ADDENDUM #01

Project Name: Central County Fire & Rescue House #06

Project Number: 24057

Date: July 7, 2026

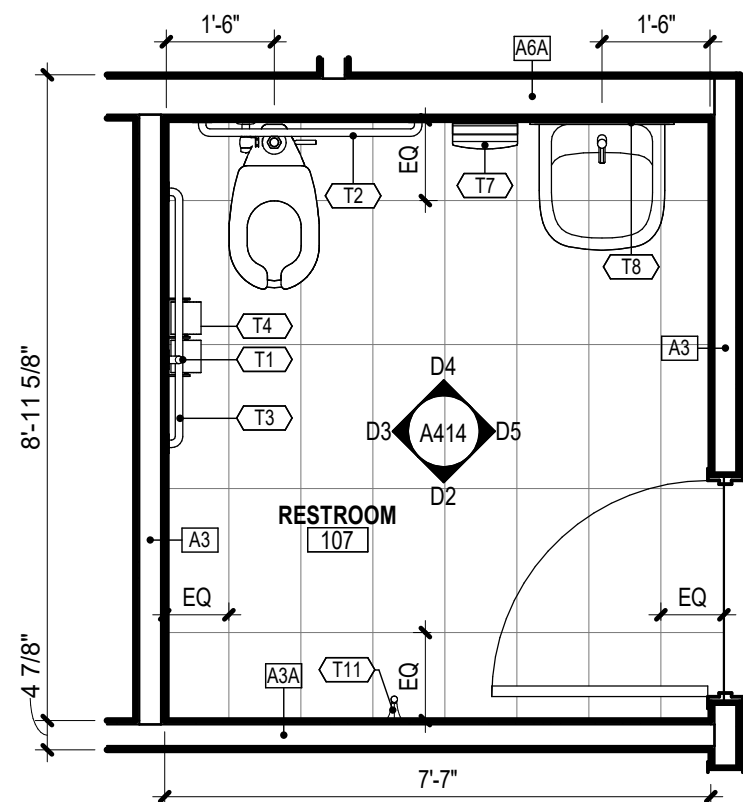
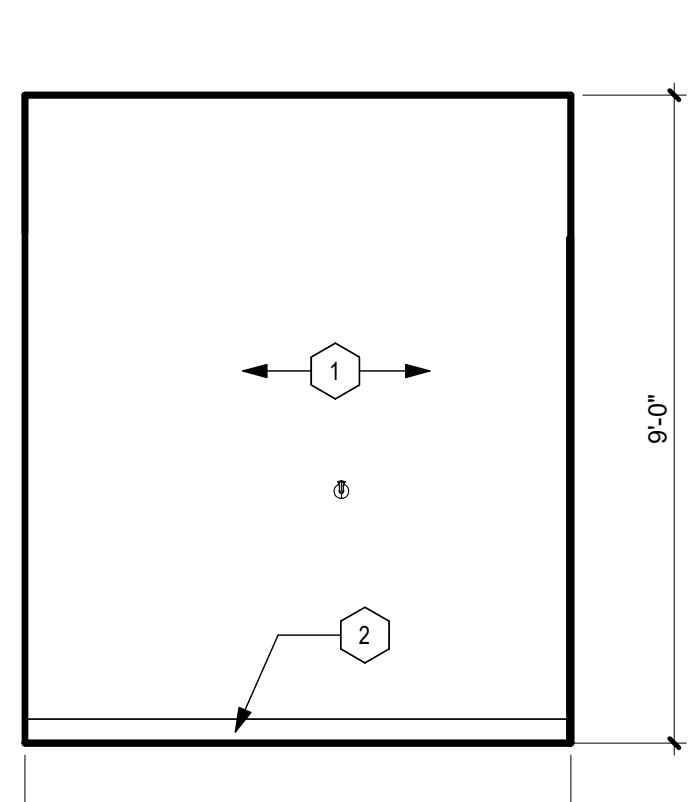
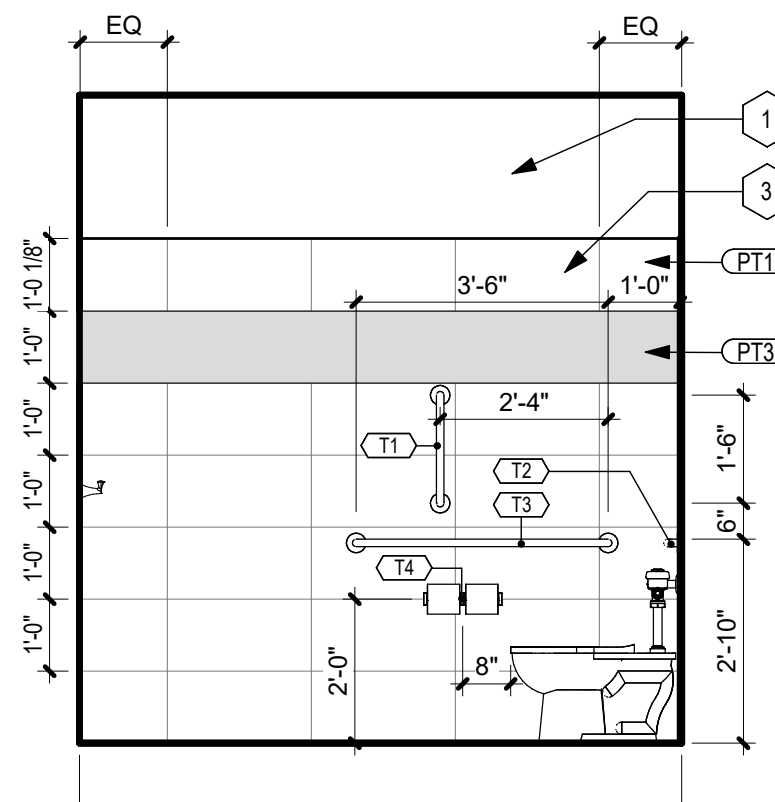
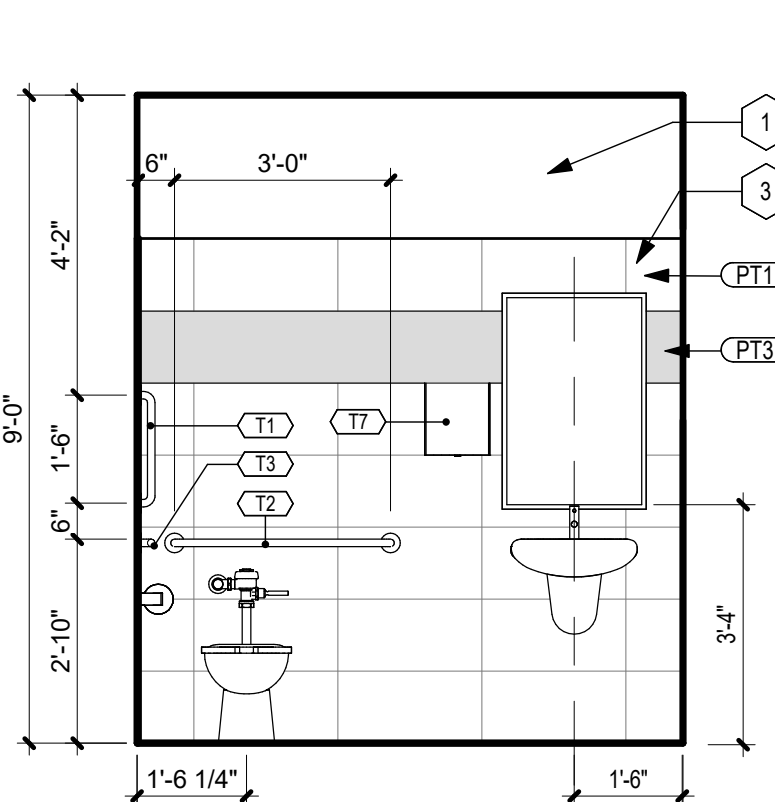
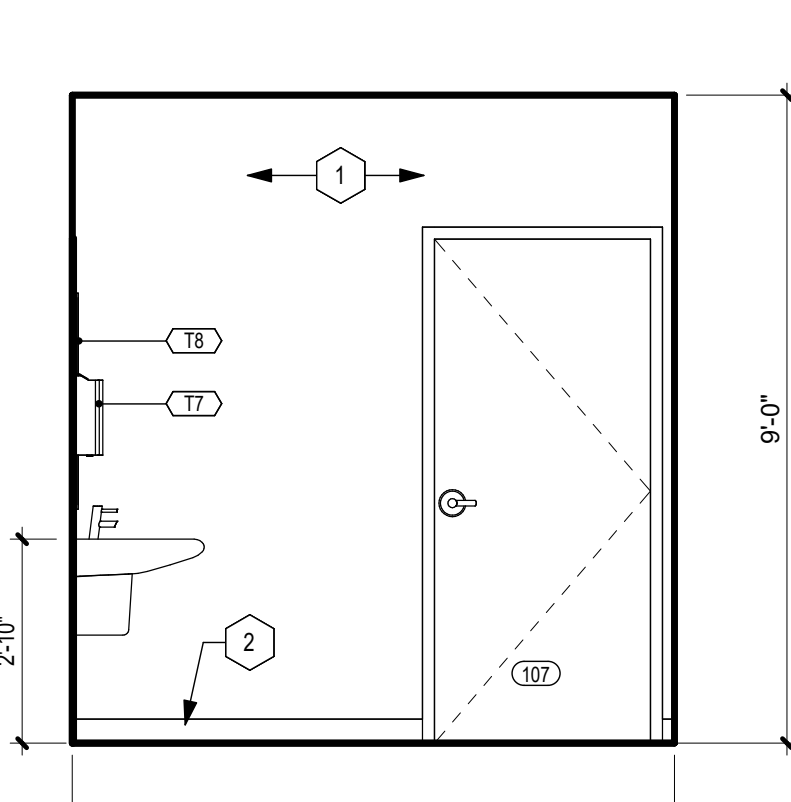
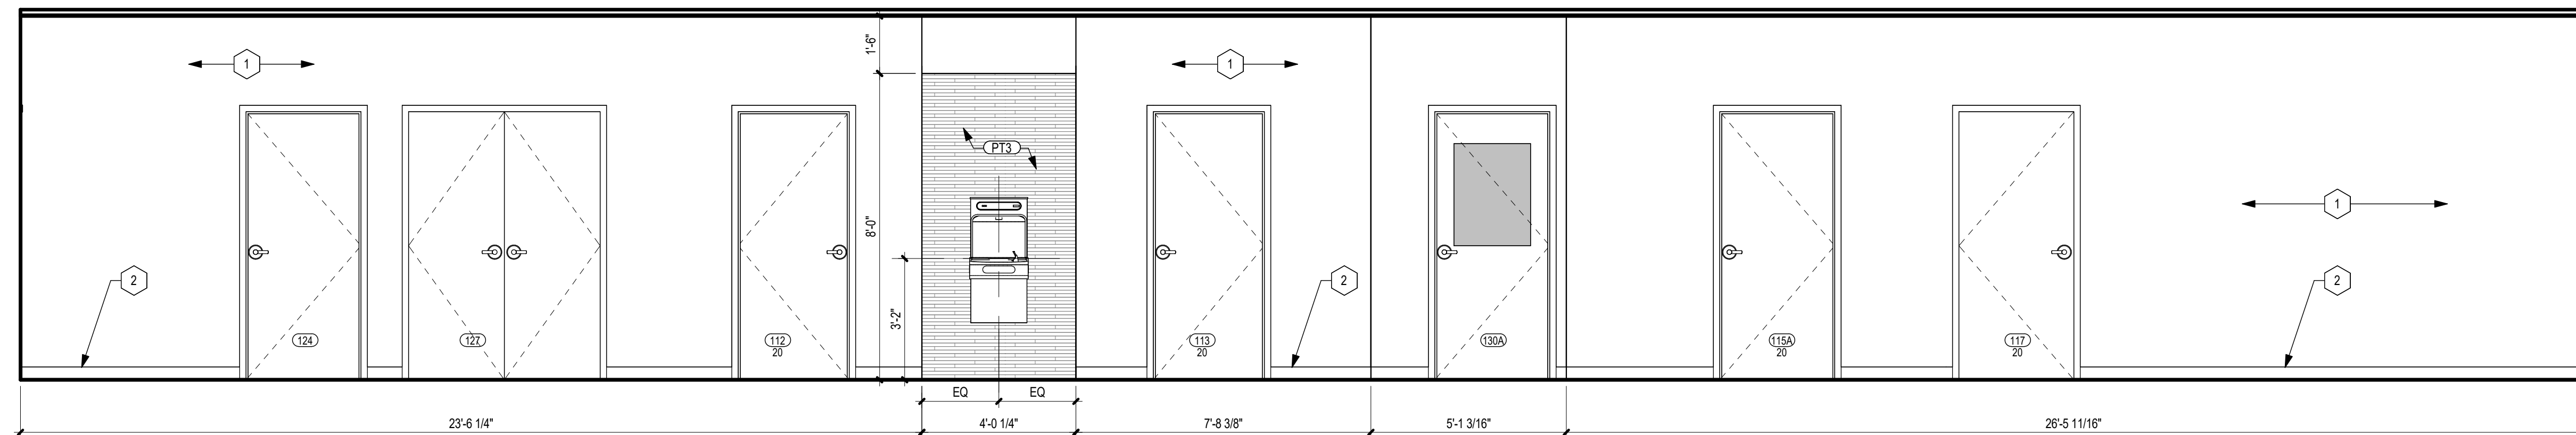
6. Sheet A414: ENLARGED FLOOR PLANS
 - a. **Added dimensions to elevations.**
 - b. **Reference attached Revised Sheet.**
7. Sheet A415: ENLARGED FLOOR PLANS
 - a. **Added dimensions to elevations.**
 - b. **Reference attached Revised Sheet.**
8. Sheet A441: INTERIOR ELEVATIONS
 - a. **Added dimensions to elevations.**
 - b. **Reference attached Revised Sheet.**
9. Sheet A601: DOOR SCHEDULE & DETAILS
 - a. **Updated door schedule.**
 - b. **Reference attached Revised Sheet.**

UNDERFLOOR PLUMBING PLAN

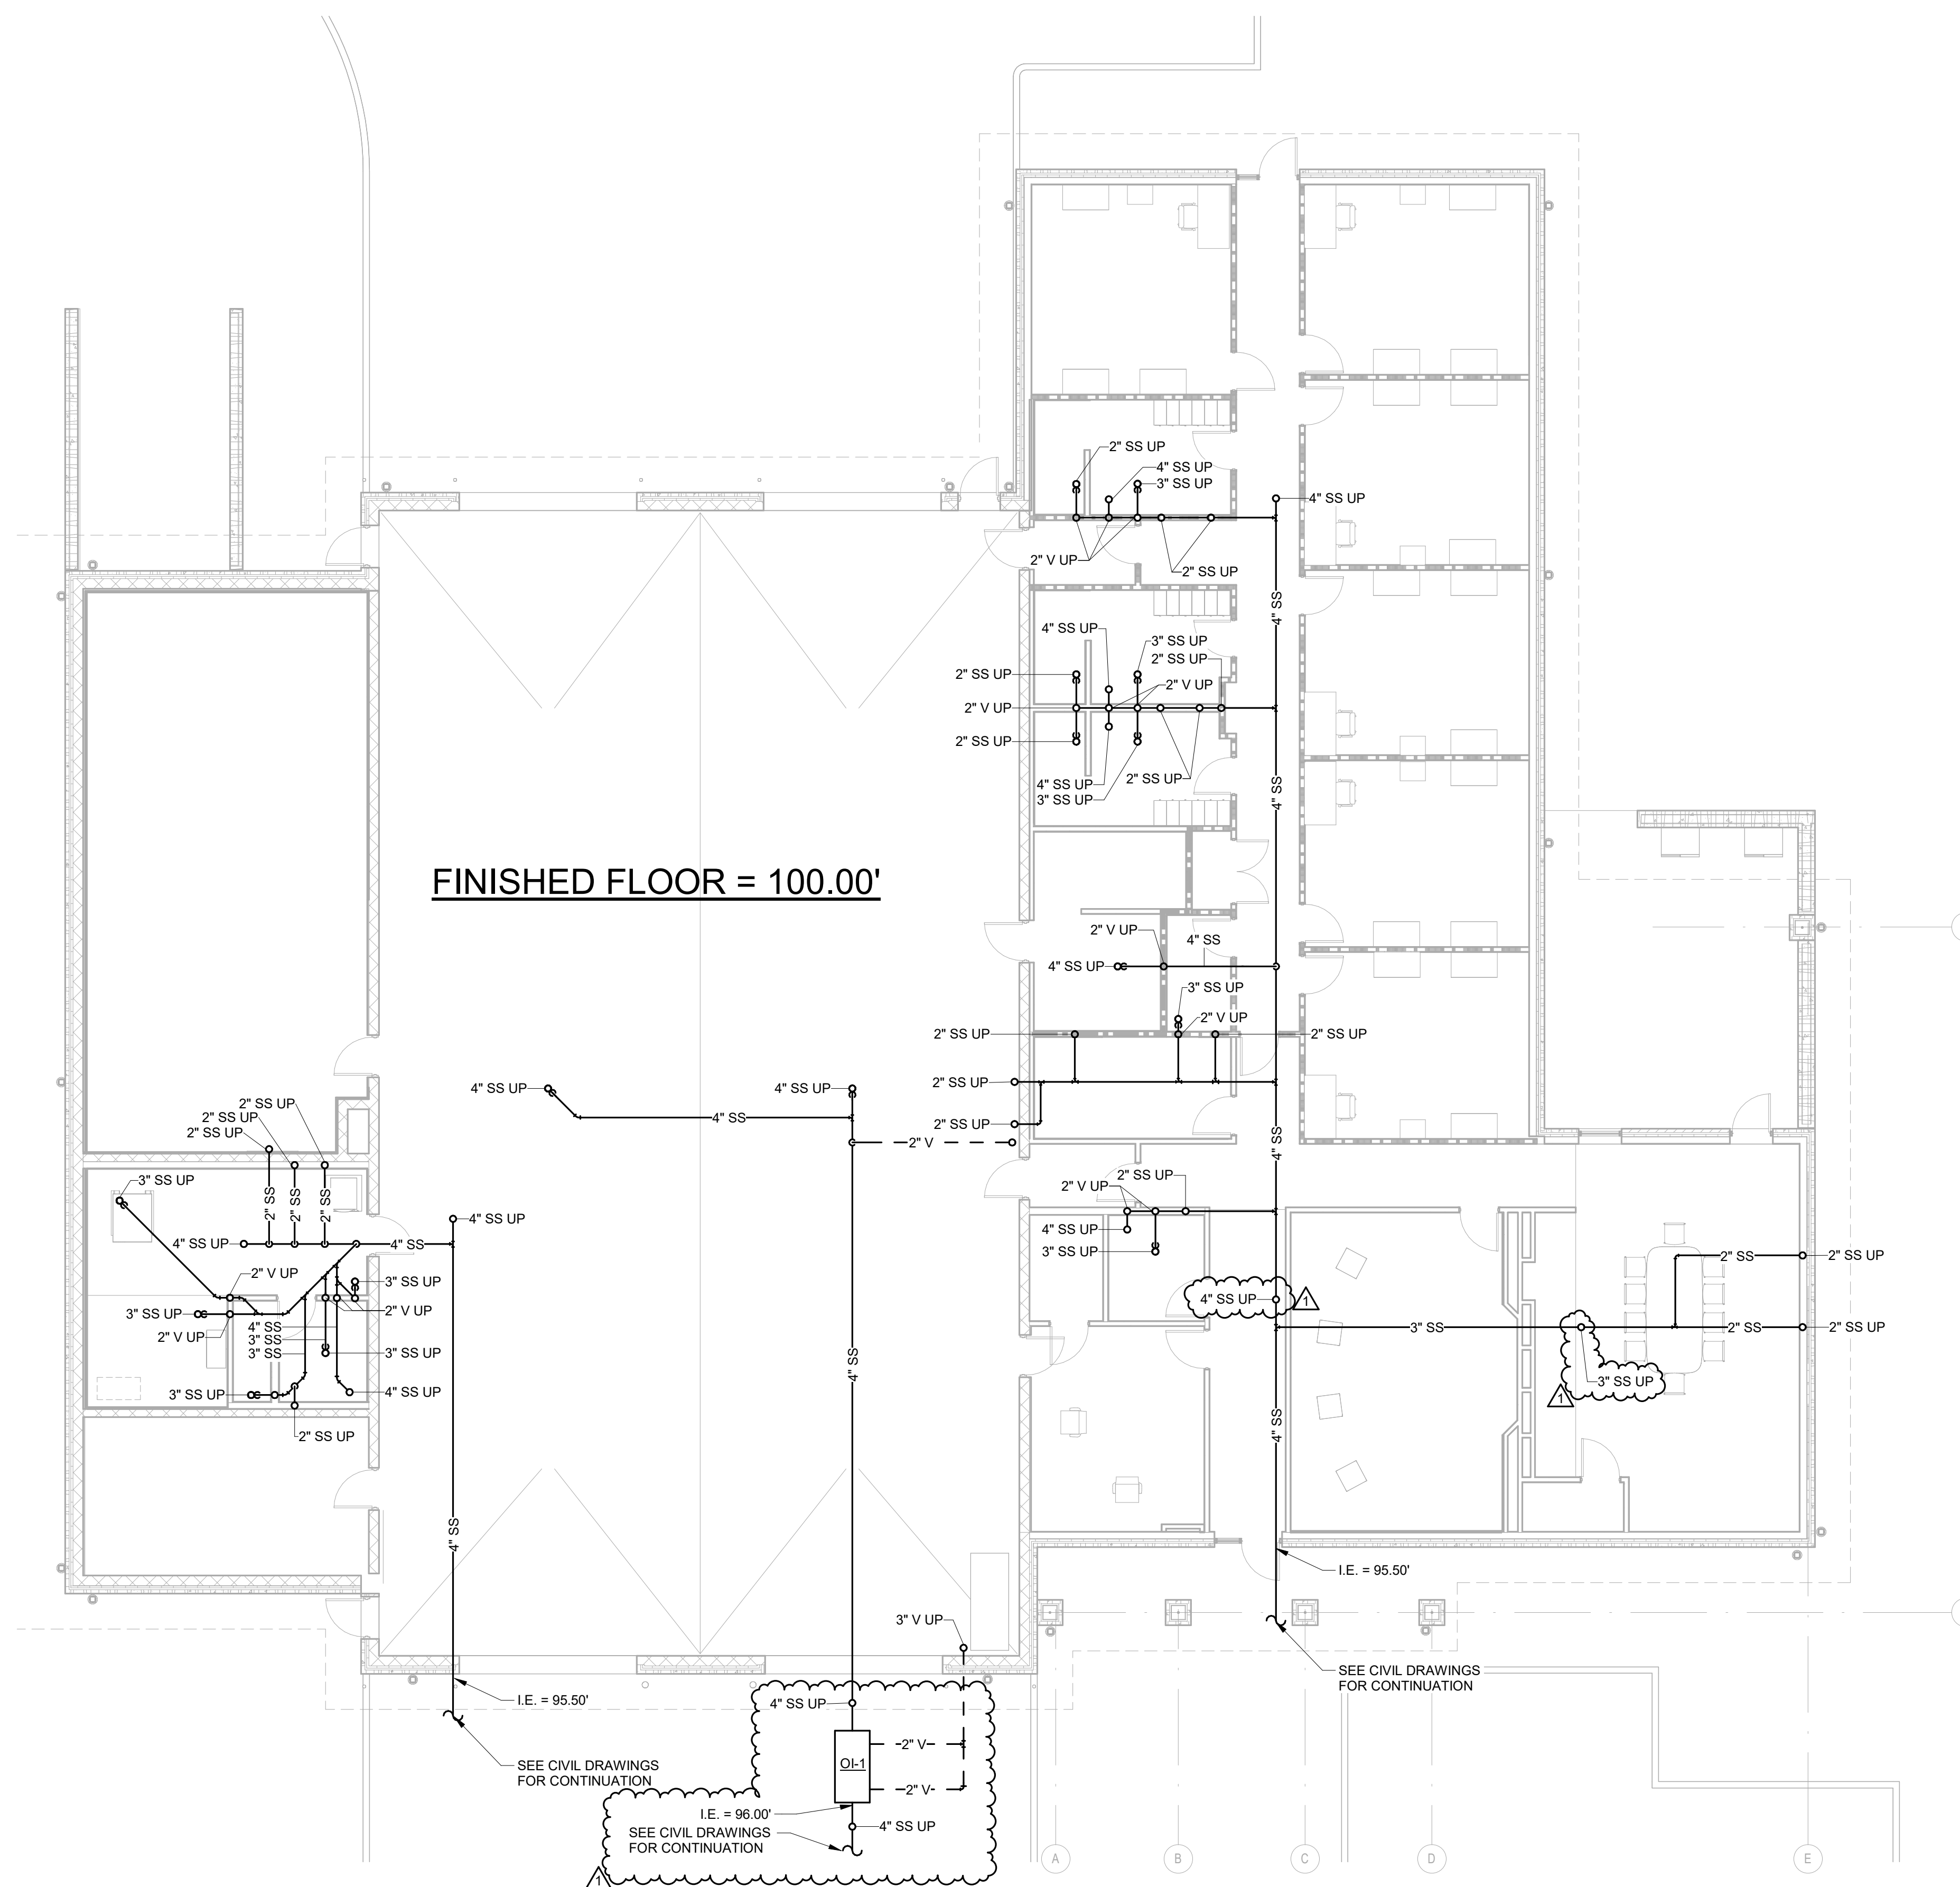
1. Sheet P200: PLUMBING UNDERFLOOR PLAN
 - a. **Revised oil interceptor orientation.**
 - b. **Added piping for a floor cleanout in the kitchen and in the corridor.**
 - c. **Reference attached Revised Sheet.**
2. Sheet P201: PLUMBING FLOOR PLAN
 - a. **Added two floor cleanouts, one in the kitchen and one in the corridor.**
 - b. **Reference attached Revised Sheet.**
3. Sheet P601: PLUMBING SCHEDULES
 - a. **Added Interceptor Schedule to sheet.**
 - b. **Revised note 5 under drain schedule.**
 - c. **Reference attached Revised Sheet.**
